Amendments to the Drawings

Appl. No. 10/810,351 Amdt. dated April 3, 2006 Reply to Office Action of October 3, 2005

Appl. No. 10/810,351 Amdt. Dated April 3, 2006 Reply to Office Action of October 3, 2005 Annotated Sheet Showing Changes

FIG. 9

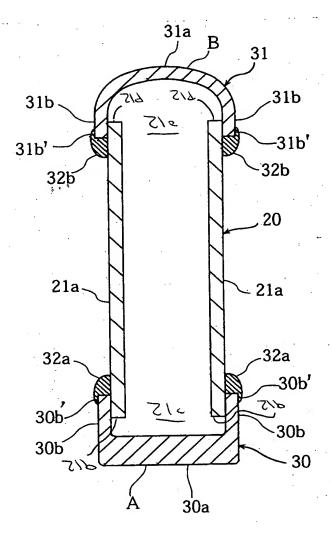
The drawings are objected to. First, the Action asserts that "an opening on an undersurface of the lower gusset" (claims 5, 6, 18 and 19) and an "opening on a top surface of the upper gusset" (claims 6 and 19) must be identified in the drawings. In response, applicant submits that these features are shown and described in both the drawings and specification. Reference is made to Fig. 9, which illustrates gusset 20 (which is a component of head pipe unit 21) defined by sidewalls 21a. Both the upper and lower portions of gusset 20 (i.e. the upper and lower gussets) are clearly open at their upper and lower surfaces. As described in paragraph [0056], there is an opening on the undersurface of lower gusset 20 that is closed by connecting wall 30a of down frame member 30. Similarly, as described in paragraph [0059], there is an opening at the top surface of gusset 20 that is closed by connecting wall 31a of tank rail member 31.

In claims 1 and 14, the Action asserts that "the sidewalls creating spaces opened outward in cross-section" is unclear. Applicant's Fig. 9 clearly shows sidewalls 30b joined by connecting wall 30a and defining a space that opens outward from the connecting wall. In order to clarify this feature, claims 1 and 14 (which are canceled, but as incorporated into claims 2-4, 8, 12 and 15-17) are amended to recite "...the sidewalls and connecting wall creating a space opened outward in cross-section...".

In claims 6 and 19, the Action asserts that "the head pipe unit has openings with each opening on a top surface of the upper gusset, and an undersurface of the lower gusset" is unclear because the "reinforcing members 31, 30d" appear to have these features. As discussed above with reference to the drawing objections, the upper and lower gussets do have the recited openings and reference characters are added to Fig. 9 for clarification. With respect to the Examiner's comment that these features appear to be a part of members 31 and 30, applicant notes that the side and connecting walls of members 31 and 30 do define spaces (as discussed with reference to claim 1), however, the top and lower surfaces of gusset 20 also define openings, as recited in claims 6 and 19.

The attached sheets of drawings include changes to Figs. 5 and 9 and replace the original sheets including Figs. 5 and 9. In Fig. 5, reference characters 20m and 20n are added to indicate a respective narrower width 20m and wider width 20n of gusset 20. In Fig. 9, reference characters 21b and 21c are added to indicate openings 21c in lower undersurfaces 21b of gusset 20, and reference characters 21d and 21e are added to indicate openings 21e in top surfaces 21d of gusset 20.

Reference characters are added to Fig. 9, and to paragraphs [0056] and [0059], to clarify this feature. The undersurfaces of gusset 20 are designated 21b and the opening at undersurfaces 21b is designated 21c. The top surfaces of gusset 20 are designated 21d and the opening at top surfaces 21d is designated 21e.
